FINAL DRAINAGE REPORT

**HAVEN SCHOOL
5490 Burgess Road
Colorado Springs, CO 80908**

July 2, 2025
Revised November 8, 2025
Revised May 14, 2026

**JPS Project No. 122401
PCD Project No. PPR2423**

DETENTION BASIN OUTLET STRUCTURE DESIGN

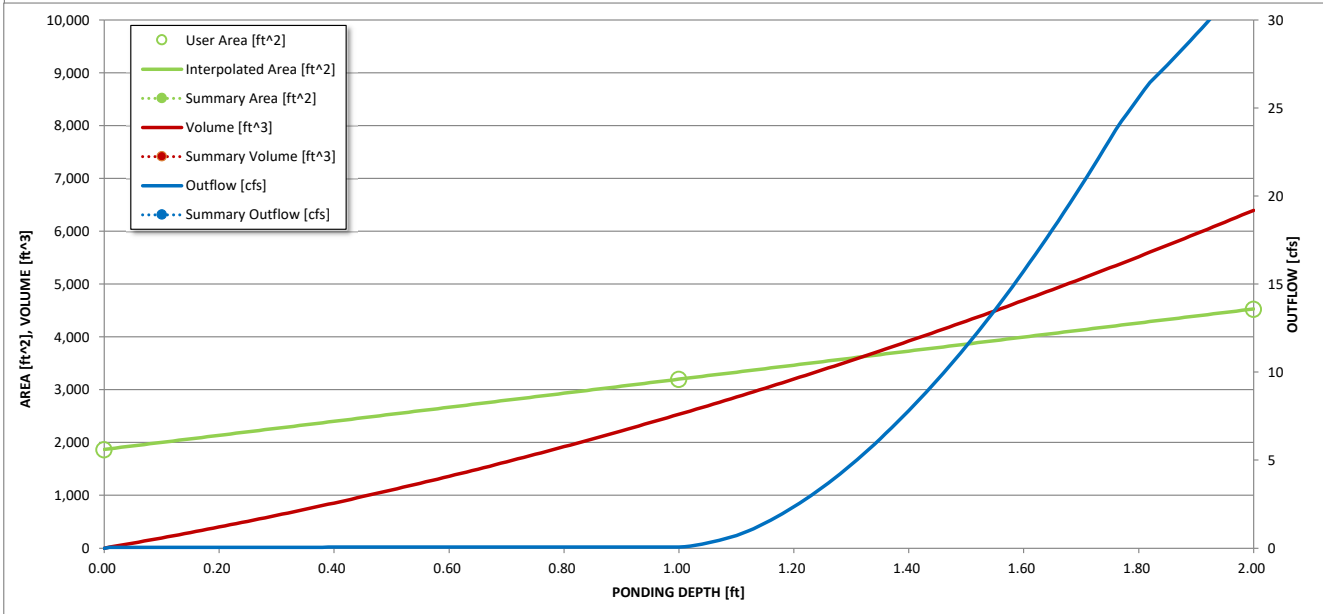
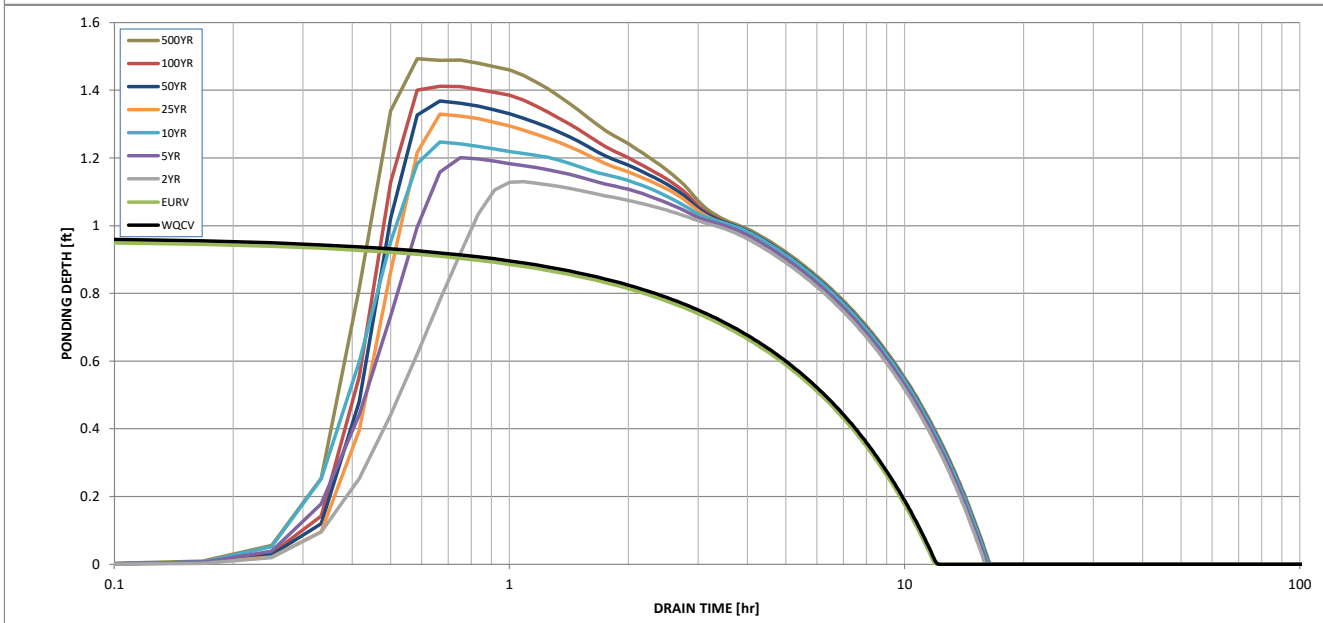
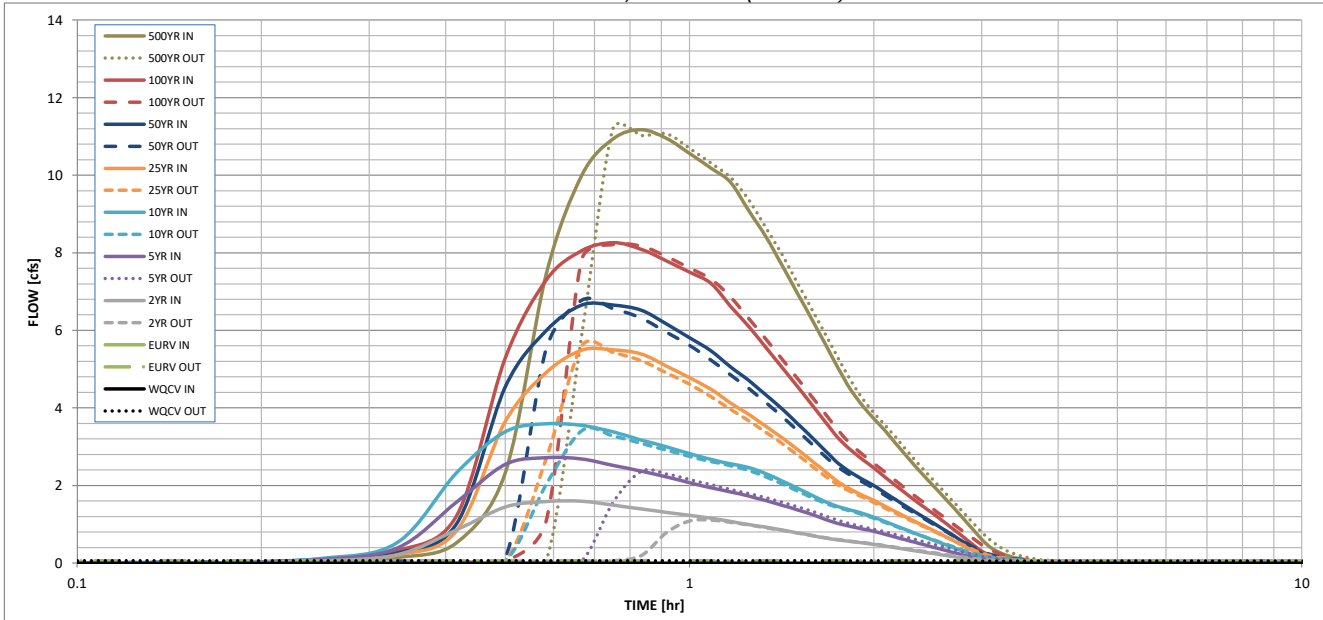
Add outlet type for the outlet structure and outlet pipe with restrictor plate.

PBMP APPLICABILITY EXHIBIT

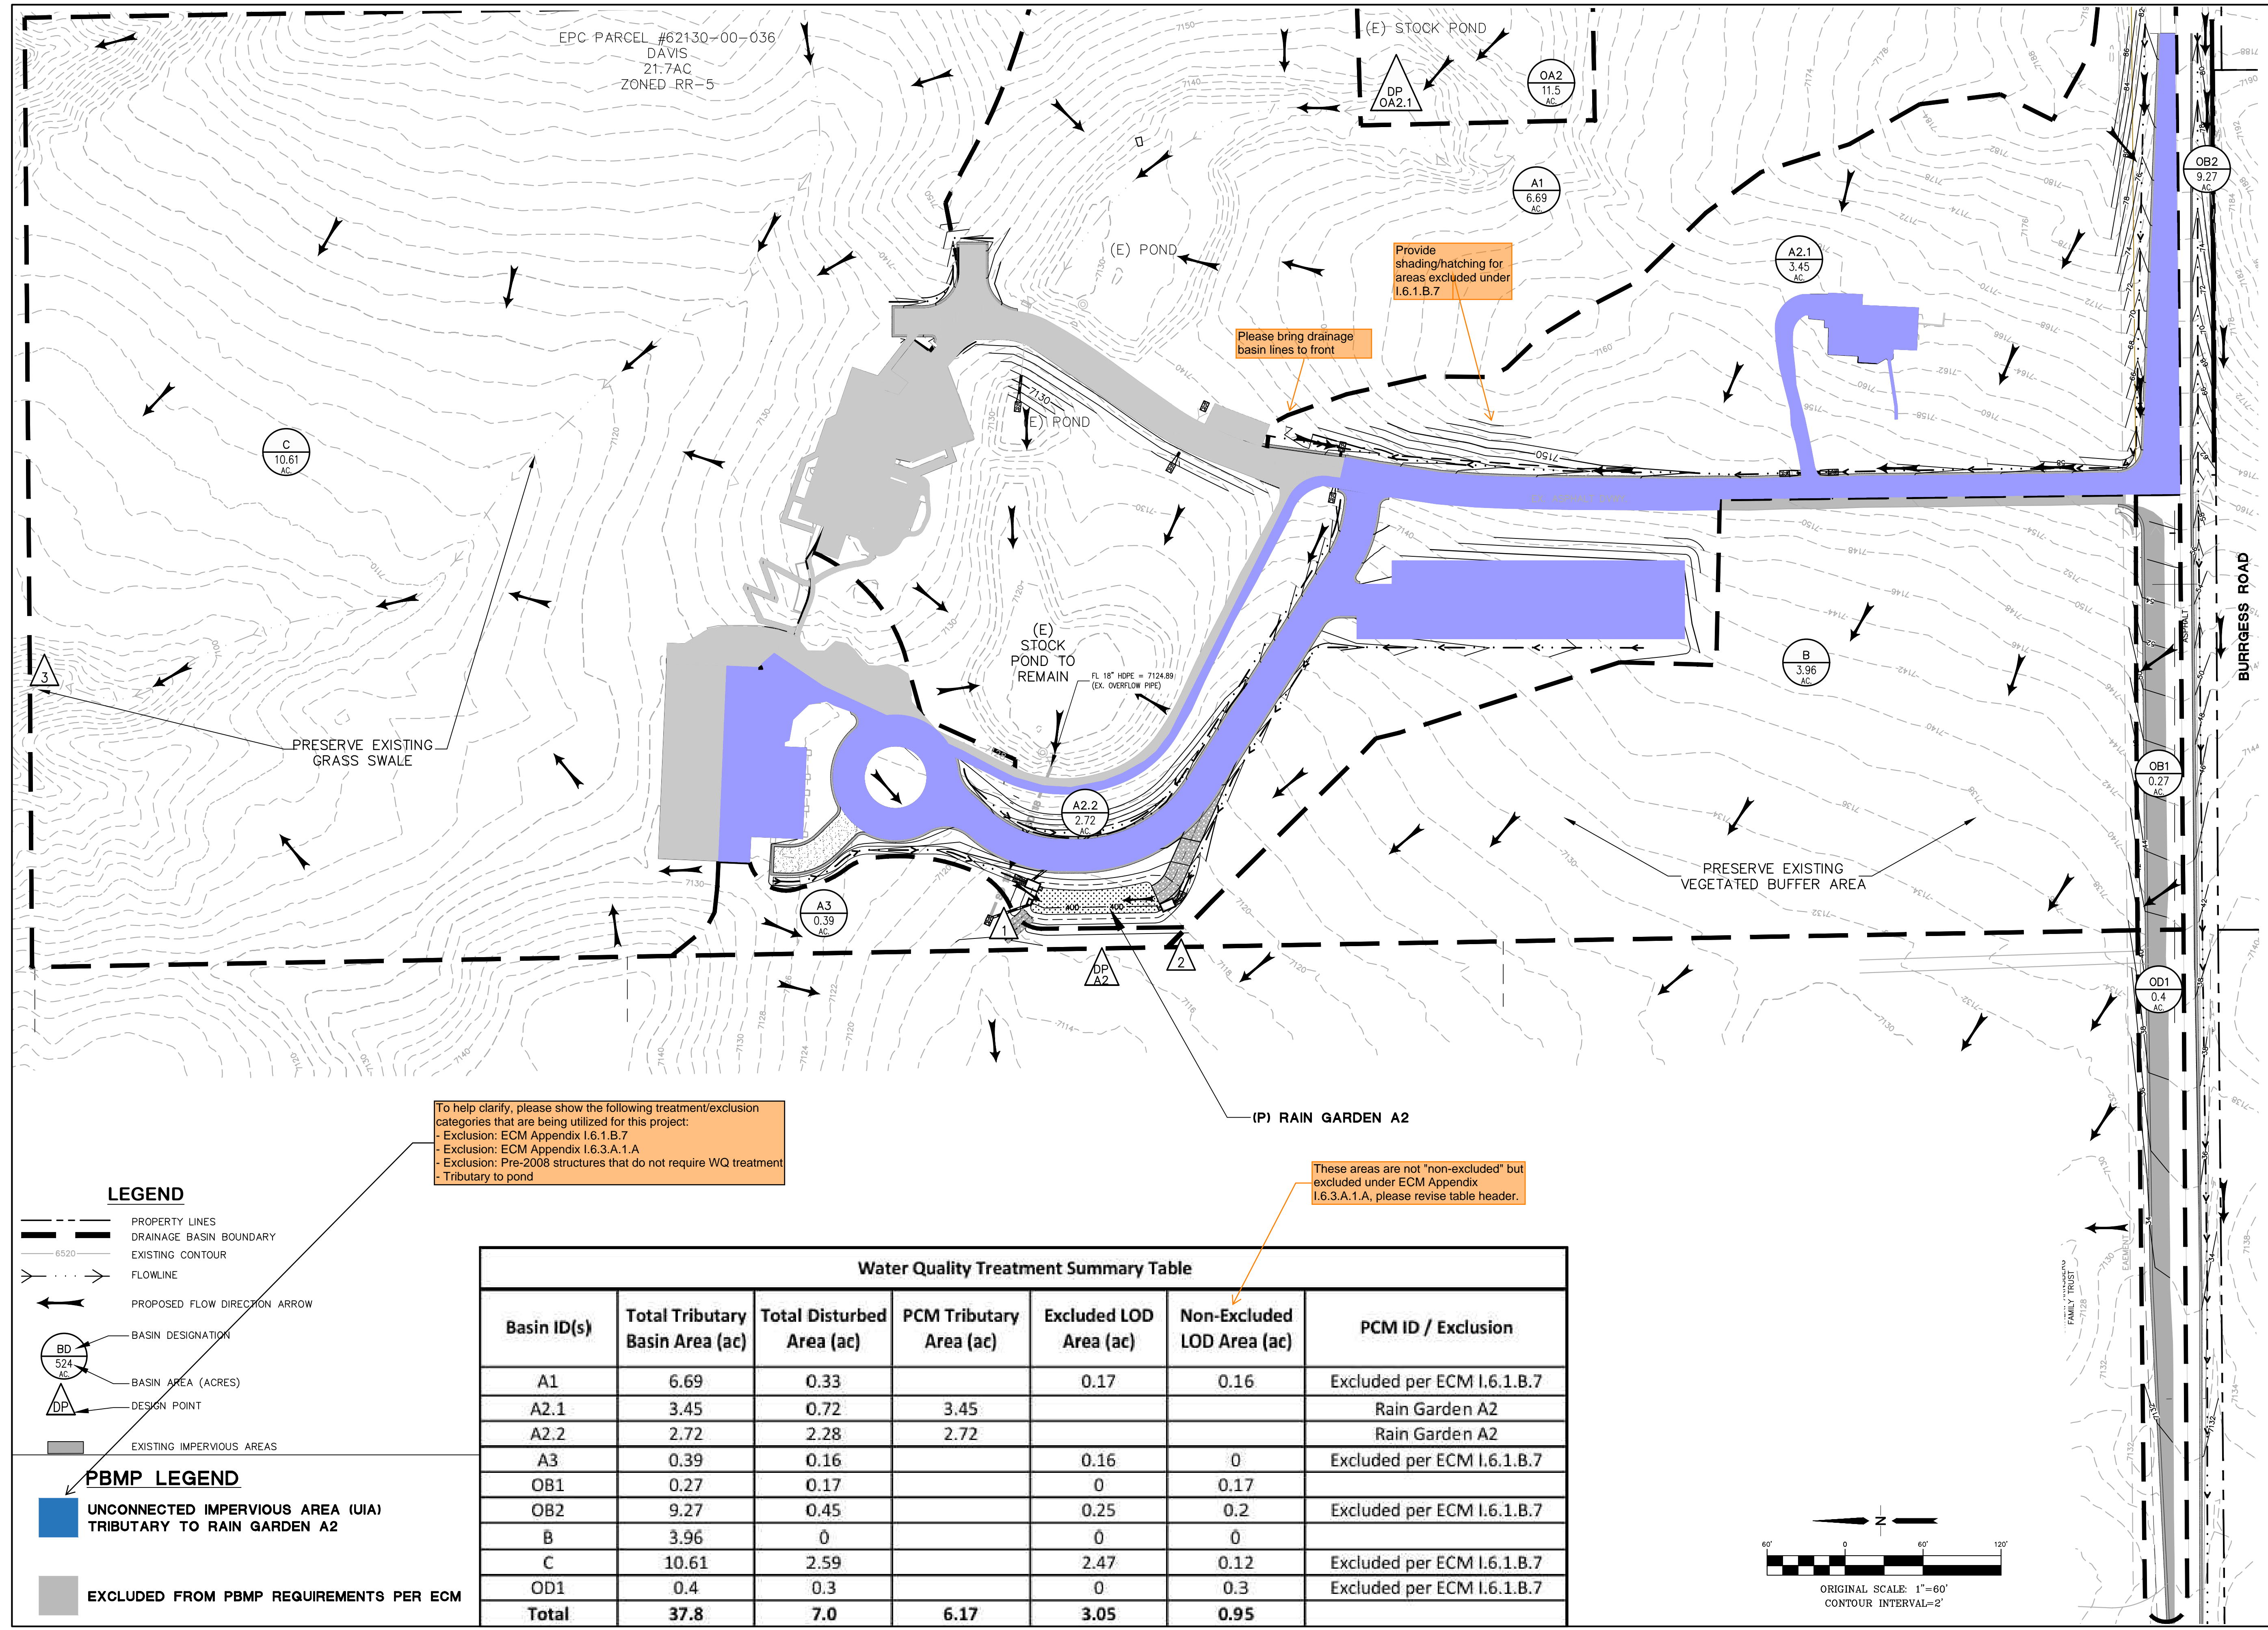
To help clarify, please show the following treatment/exclusion categories that are being utilized for this project:
 - Exclusion: ECM Appendix I.6.1.B.7
 - Exclusion: ECM Appendix I.6.3.A.1.A
 - Exclusion: Pre-2008 structures that do not require WQ treatment
 - Tributary to pond

These areas are not "non-excluded" but excluded under ECM Appendix I.6.3.A.1.A, please revise table header.

SHEET: **PBMP**

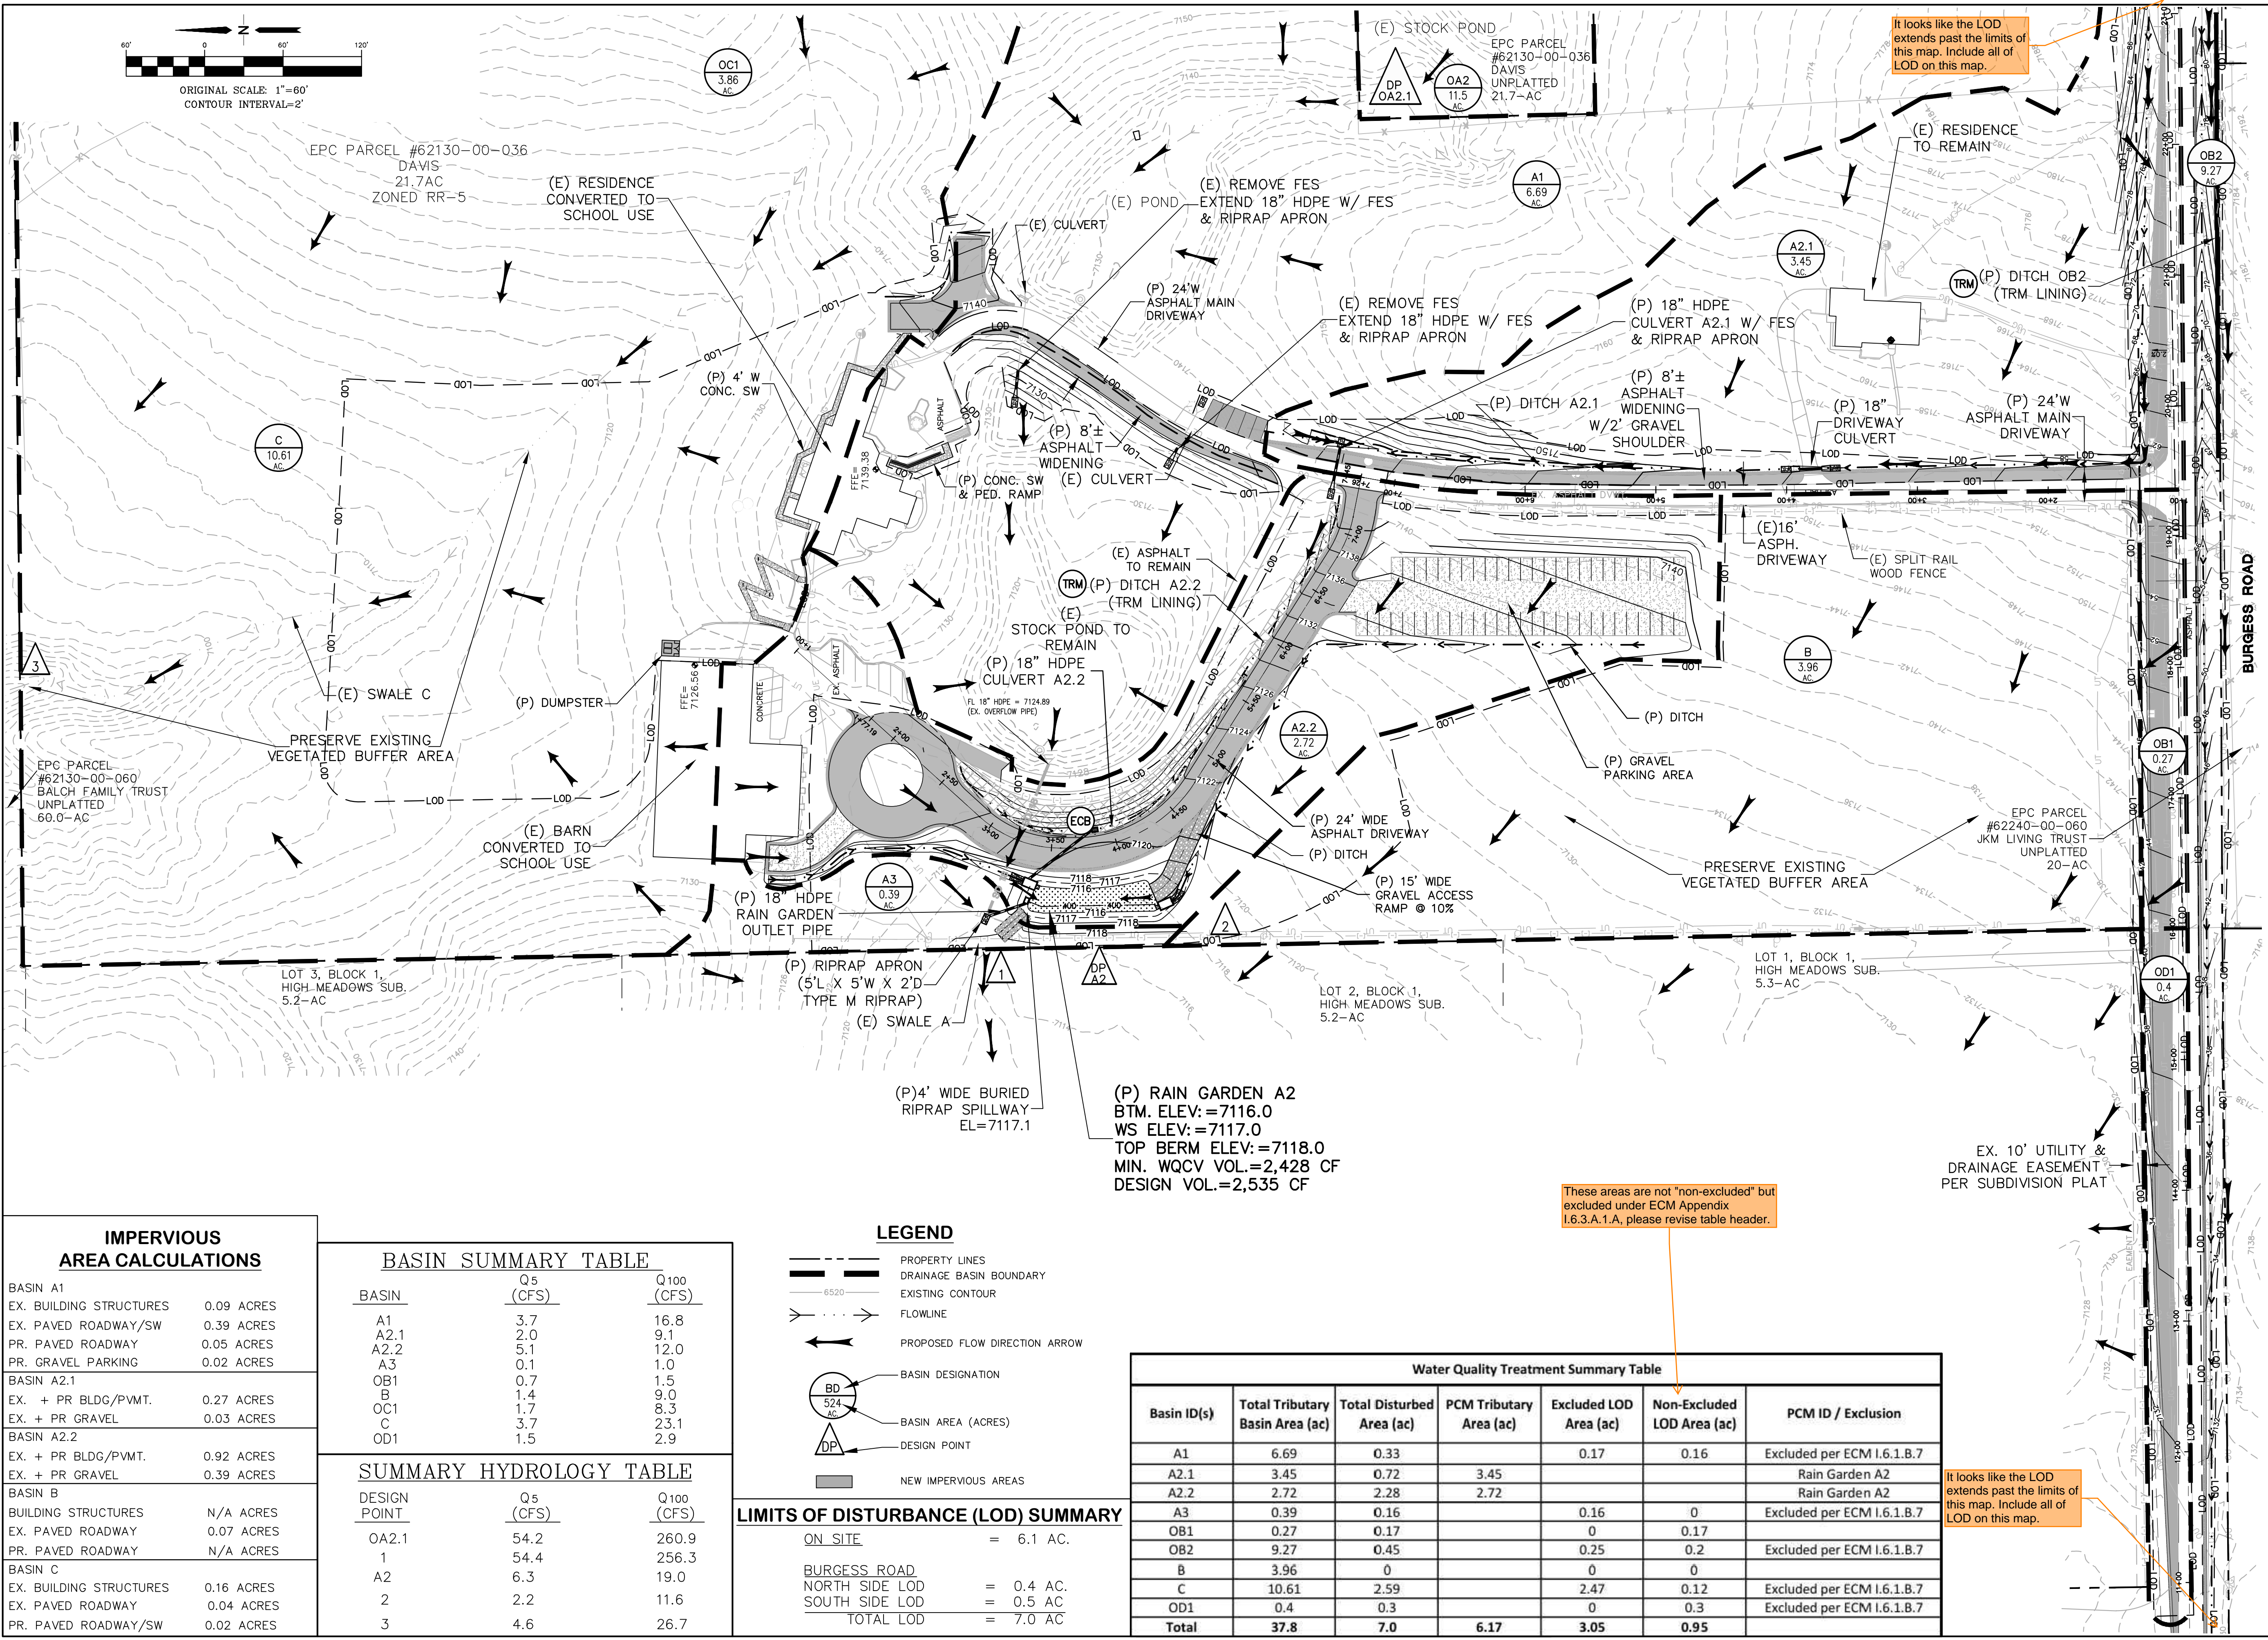
It looks like the LOD extends past the limits of this map. Include all of LOD on this map.

These areas are not "non-excluded" but excluded under ECM Appendix I.6.3.A.1.A, please revise table header.
